**MODIFICATIONS TO THE PASSENGER SEAT-BELT
TIEDOWN ATTACHMENTS IN THE**

U.S. ARMY HU-1 SERIES BELL IROQUOIS HELICOPTER

TCREC Technical Report 62-45

Crash Injury Bulletin
AvCIR 62-1

Figure 2. Typical Seat-Belt Tiedown Installation in the HU-1 Helicopter.

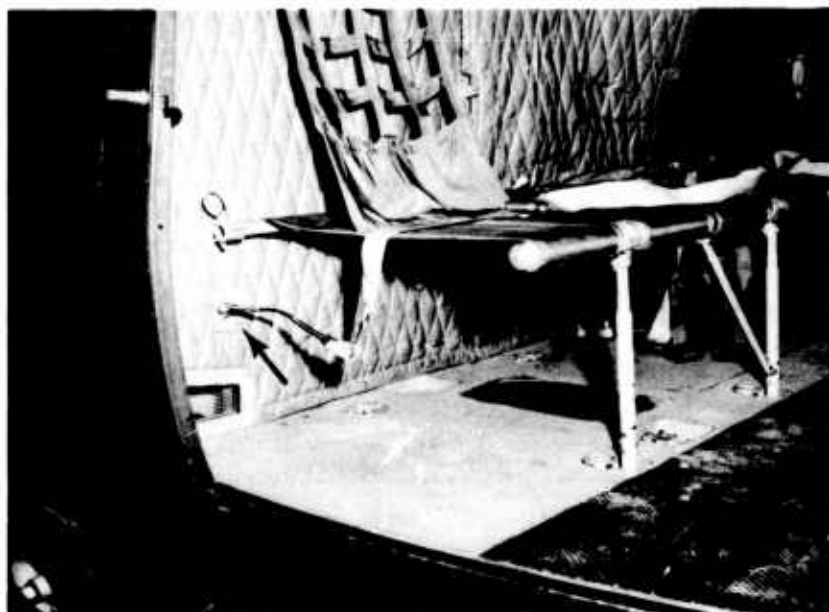
A review of several HU-1 helicopter accidents* reveals that failure of the passenger seat-belt tiedown occurs at the casting where the cable clevis is attached.

Figure 2 illustrates the tiedown installation as presently installed in HU-1 helicopters.

Note that lateral movement is not possible at the point where the fork-end is attached to the casting. Excessive bending stresses at the attachment flange of the seat-belt tiedown bracket can be produced by side loads transmitted through the seat belt.

Figure 5. Suggested Interim Configuration.

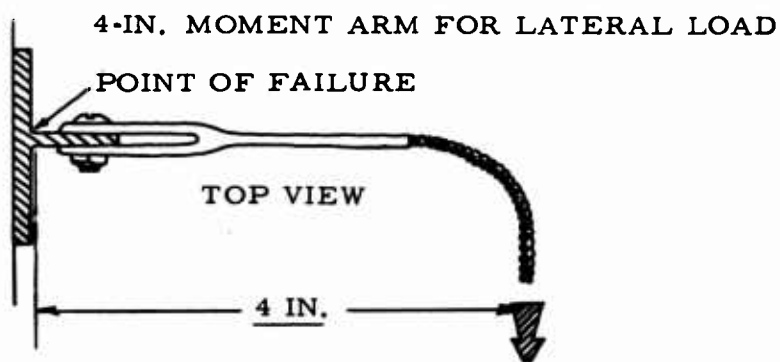
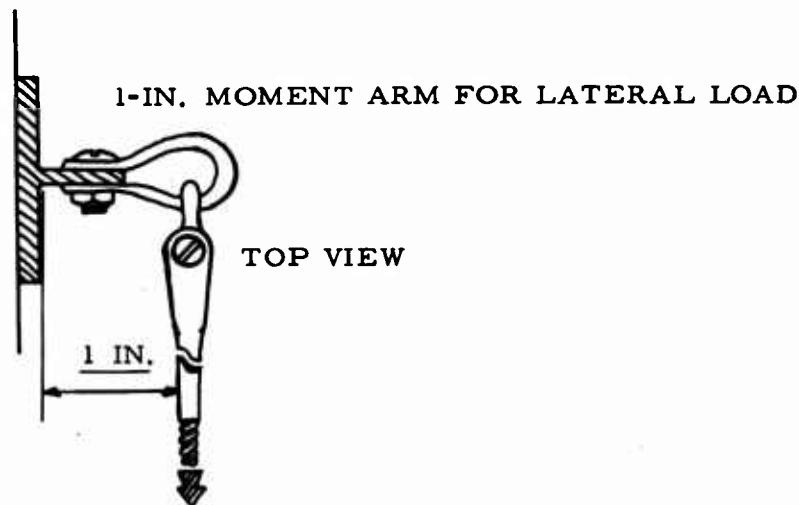
The present cable attachment provides a moment arm of approximately 4 inches when side loads are applied as shown in Figure 4. With this moment arm, only 800 inch-pounds (4 inches x 200 pounds) of direct side moment are required to break the attachment casting.

The 4-inch moment arm could be reduced to 1 inch if two "off-the-shelf" cable shackles were installed between the end of the cable terminal and the tiedown bracket, as illustrated in Figures 4 and 5.

This simple arrangement would increase side load capacity by 400 percent. It would also make the attachment omnidirectional and could be quickly installed in the field with available "off-the-shelf" components.

1. Separate the fork-end cable terminal from the tiedown bracket by removing the nut and bolt.
2. Interlock two cable shackles.
3. Using the same nut and bolt that held the fork-end cable terminal to the bracket, assemble one of the interlocked cable shackles to the bracket.
4. Disassemble the nut and bolt securing the ring coupling that is attached to the eye-end cable terminal and the seat-belt fitting, thus freeing the cable.
5. Reverse the cable, then insert the eye-end cable terminal in the remaining interlocked cable shackle and secure with the AN 25-14 bolt and AN 364-524A nut.
6. Insert the bolt that secured the ring coupling in the fork-end cable terminal and secure with its nut.
7. Attach the seat-belt snap hook fitting to the fork-end cable terminal at the bolt.
